Project Name: Madison County Schools - Madison Central Press Box Improvements

Project Number: 25-053

ADDENDUM NO. 01

4 FIRST FLOOR PLAN - MEN'S RR
 1/4" = 1'-0"

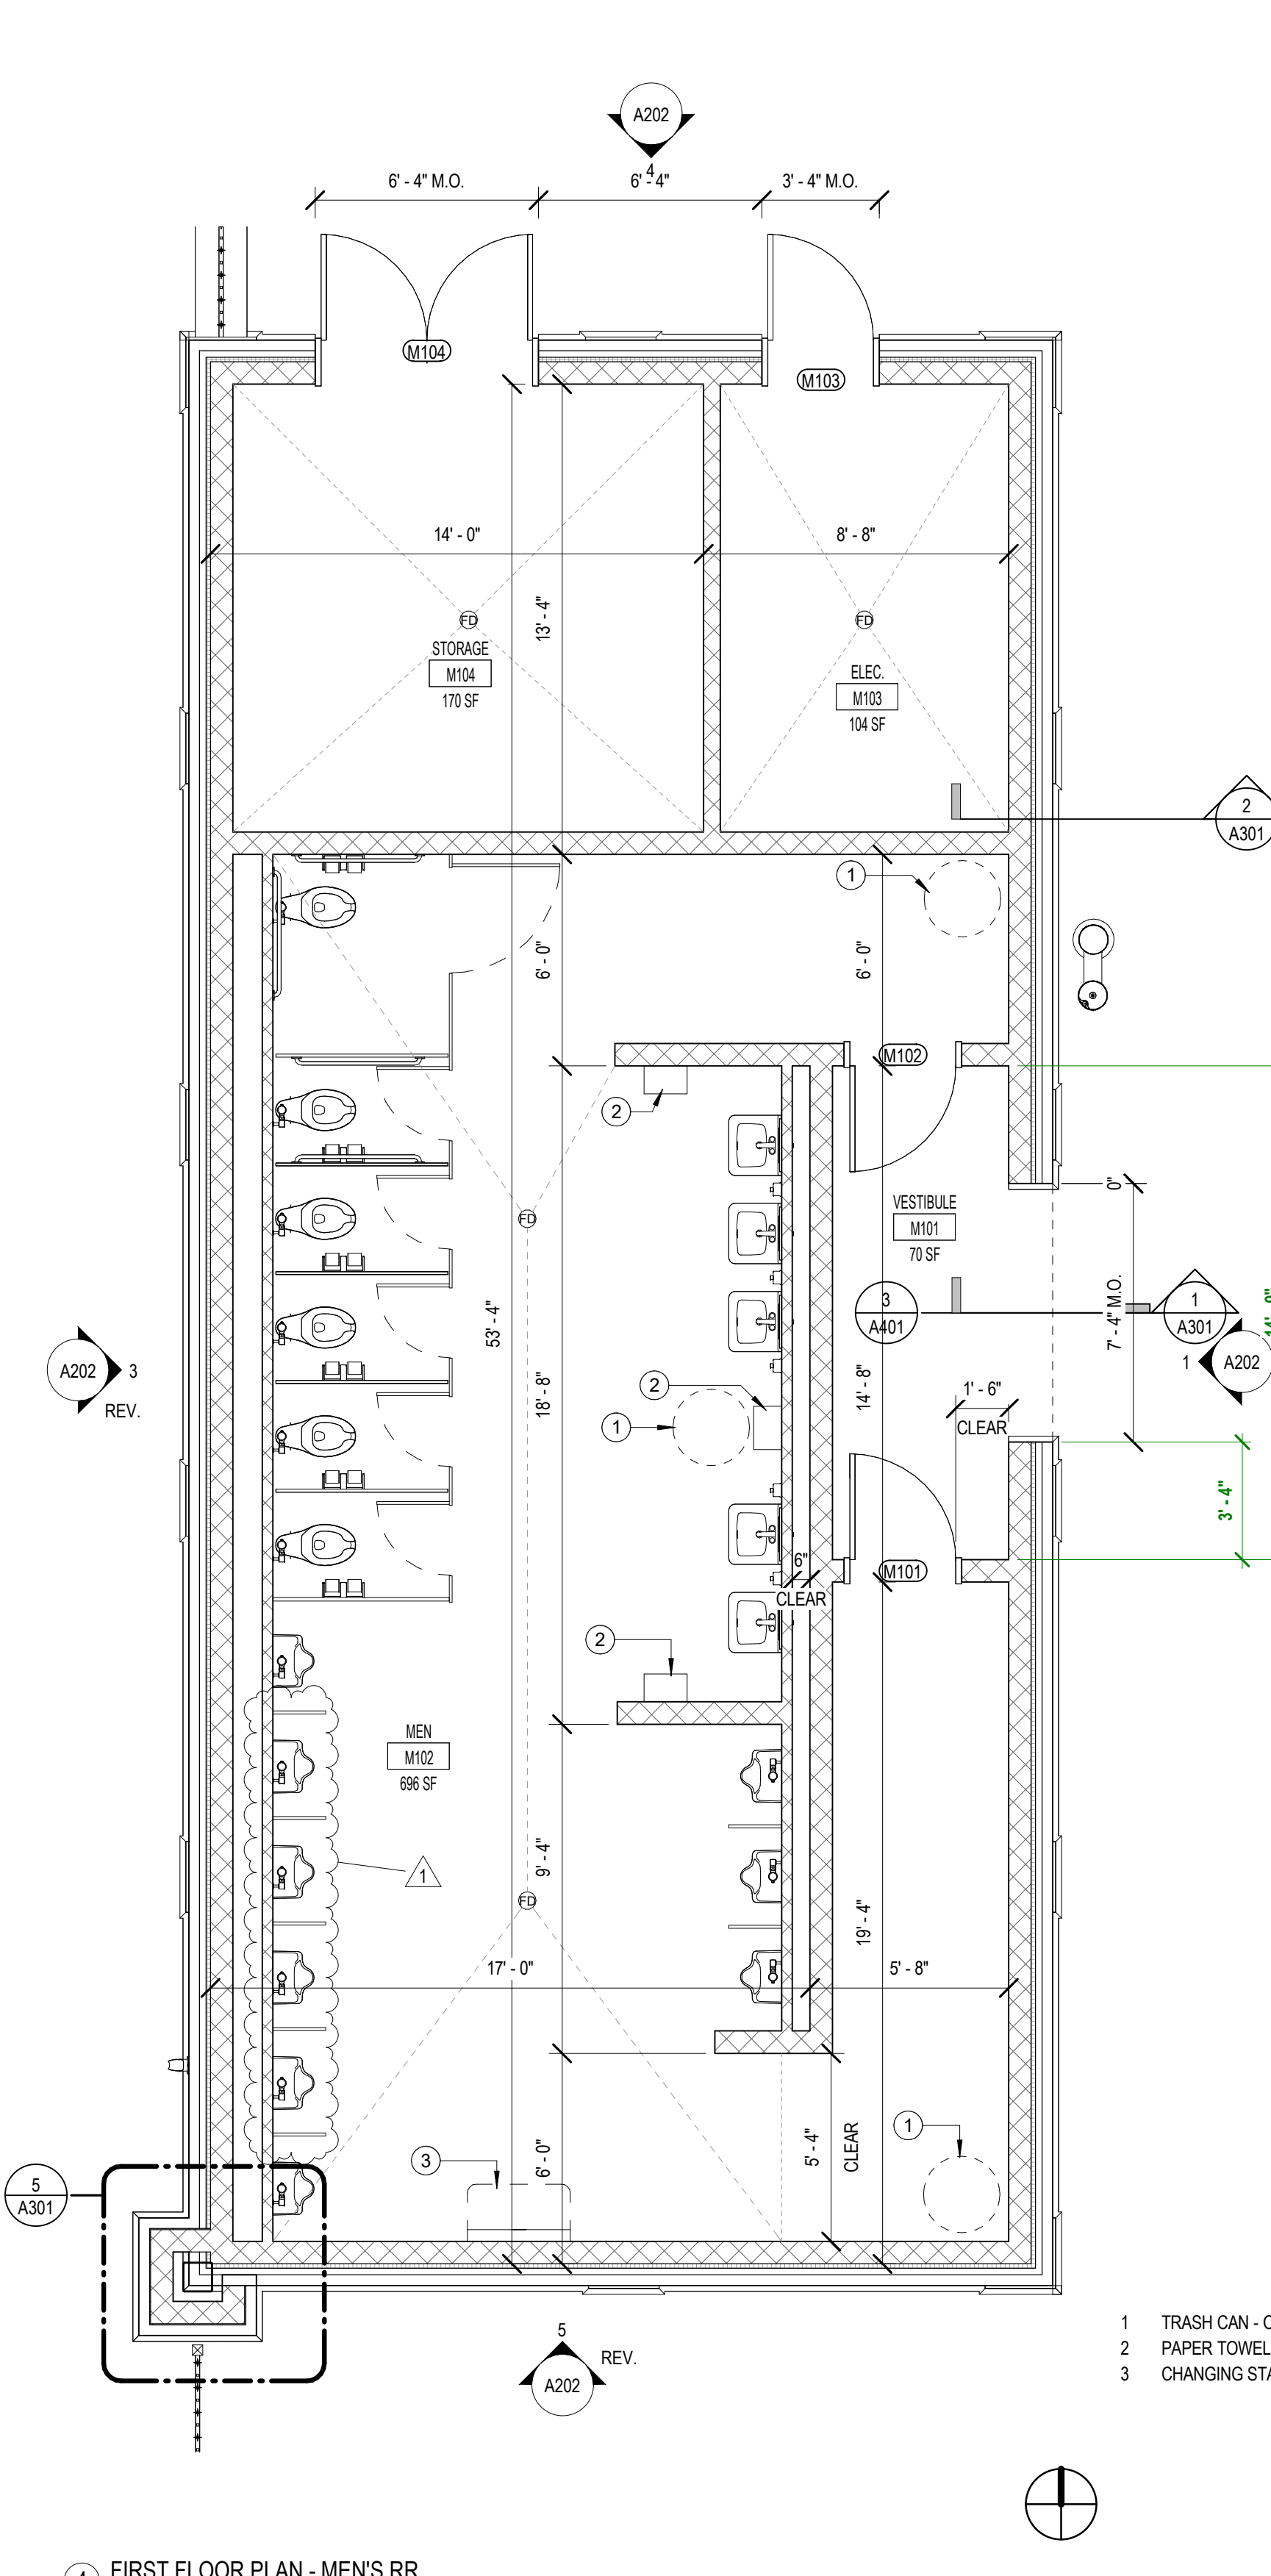
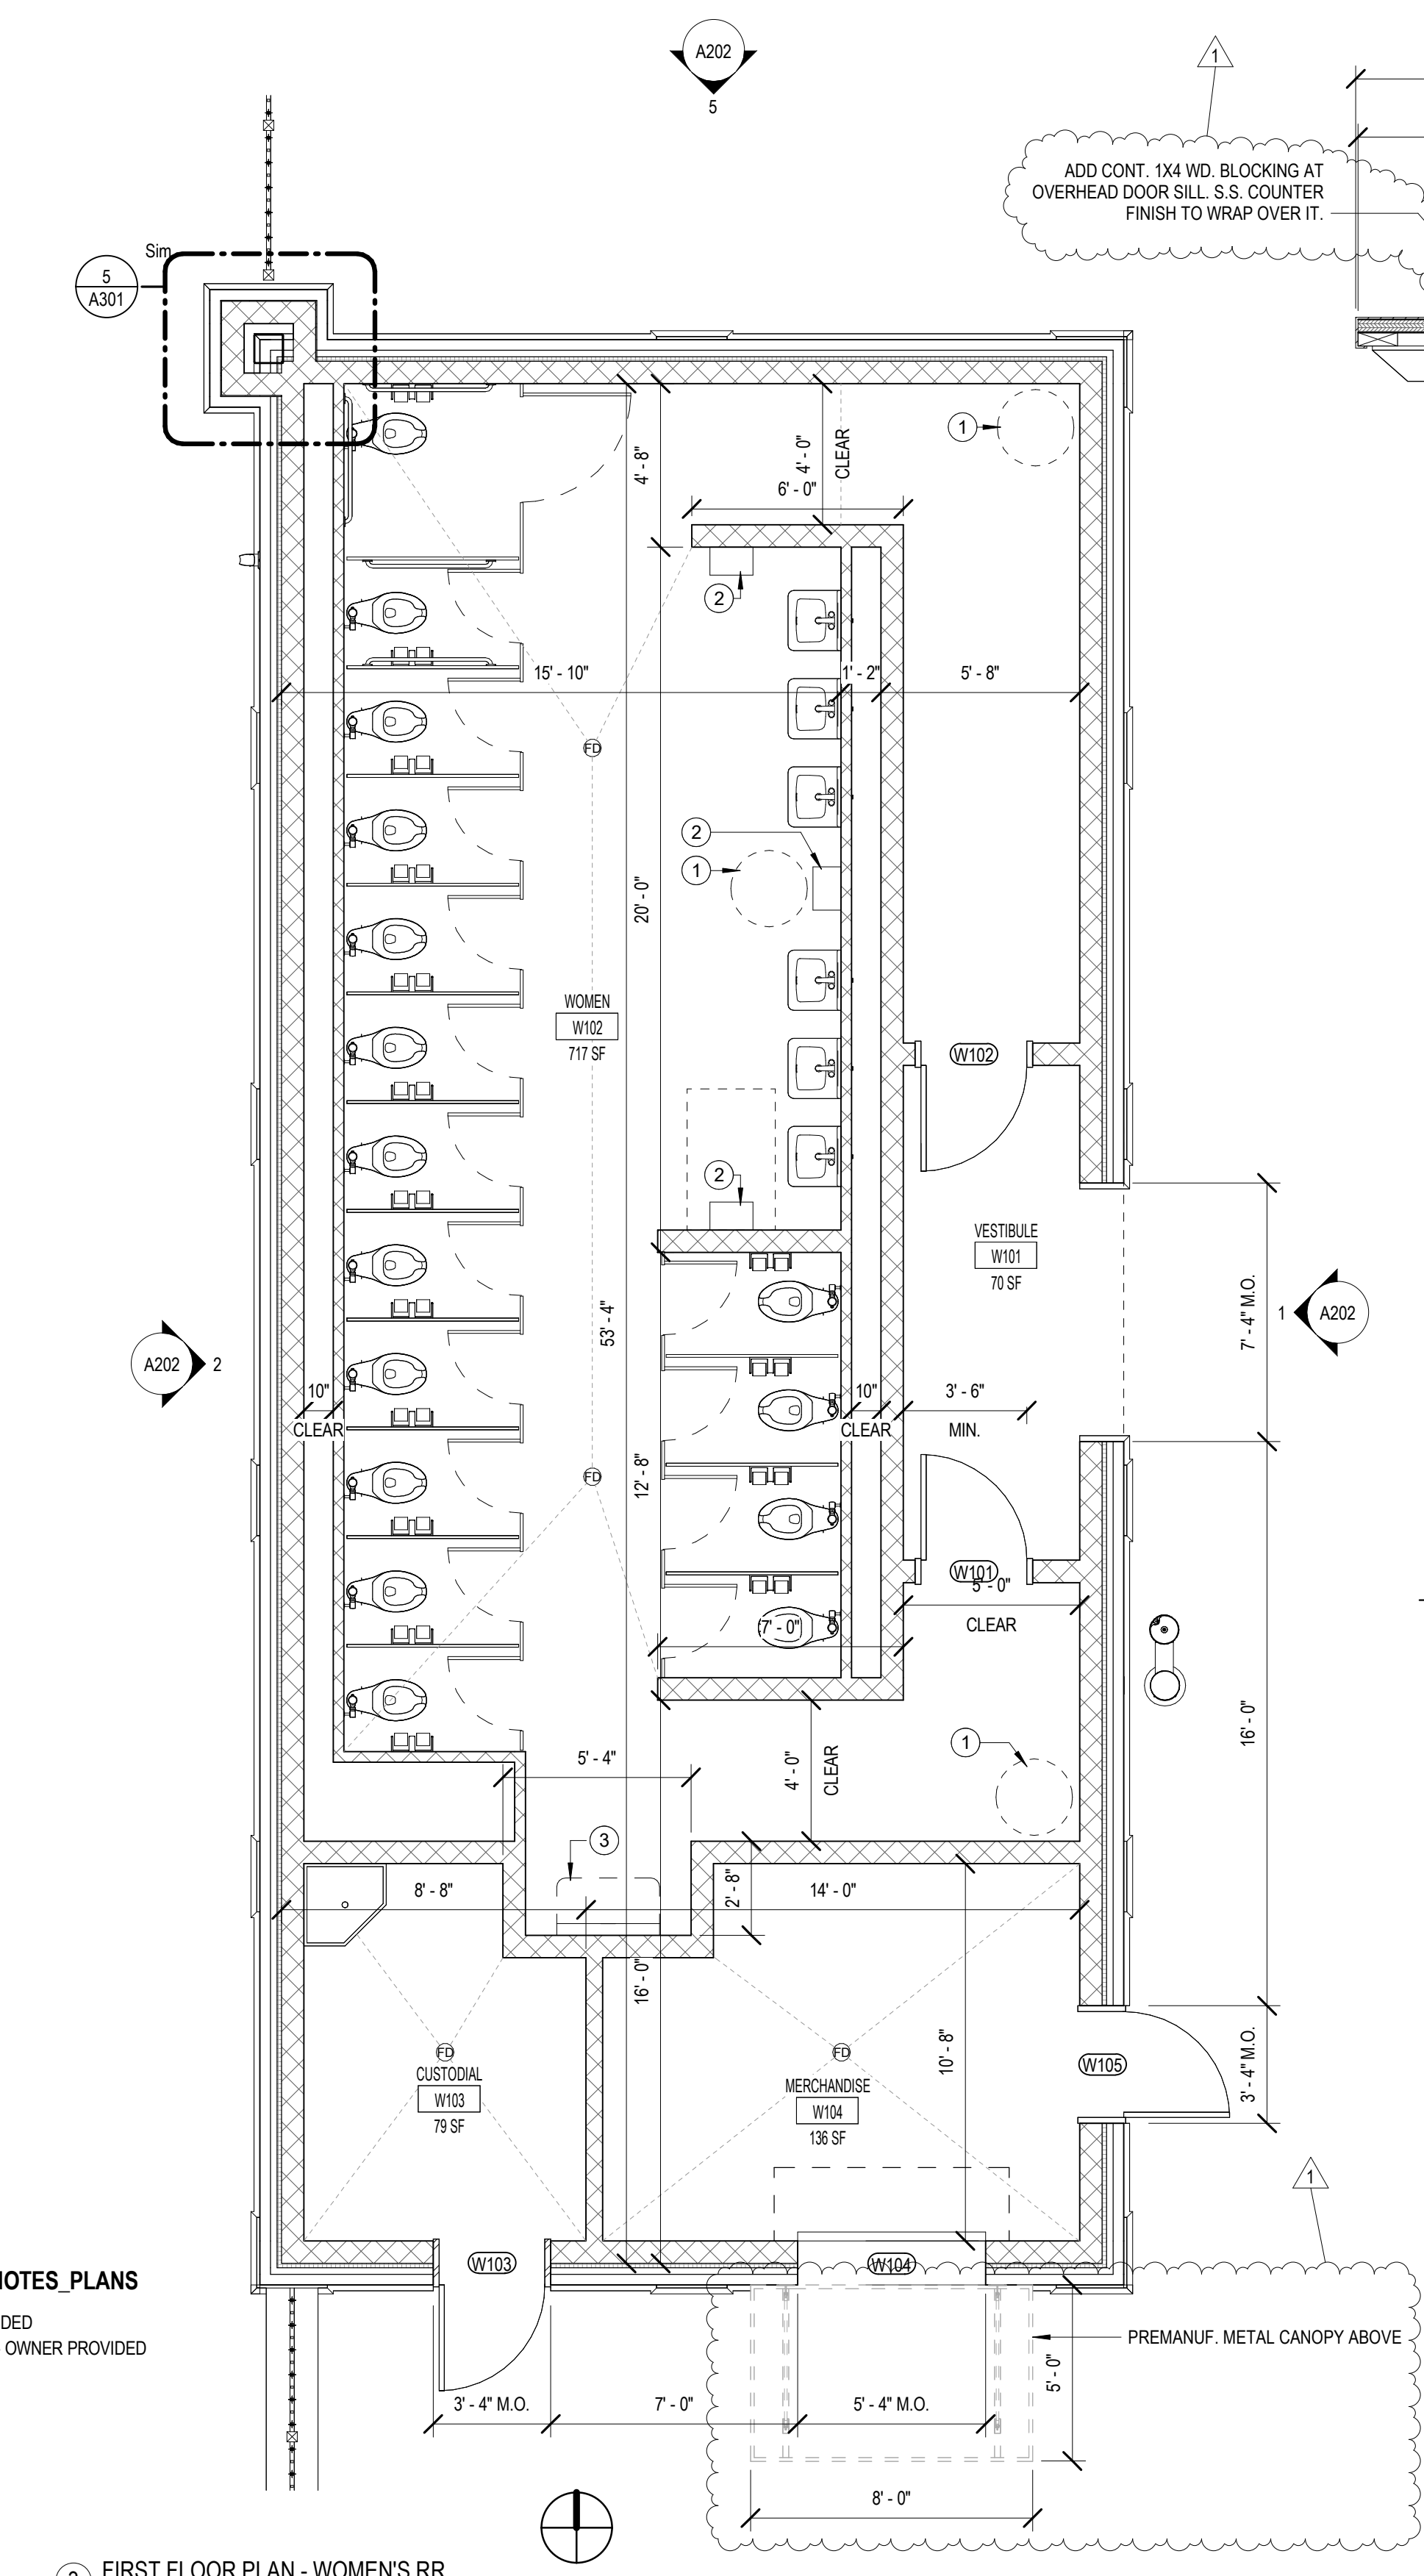
- ITEM NO. 23 **A101 TOILET ROOM PLANS**
CLARIFICATION on the size of the pre-manufactured aluminum canopy.
CLARIFICATION: There WILL be urinal screens between all urinals in the men’s restroom.
CLARIFICATION: Revised “FINISHES” note. There are no finished ceilings in any spaces of the restroom buildings. All spaces are exposed to the underside of the decking.
CLARIFICATION on interior wall types: All interior walls in the restroom buildings are either 8” CMU or 4” CMU, as visually indicated on the floor plans.
REVISE detail 7/A101 at stainless steel countertop.
ADD ADA signage at restrooms.
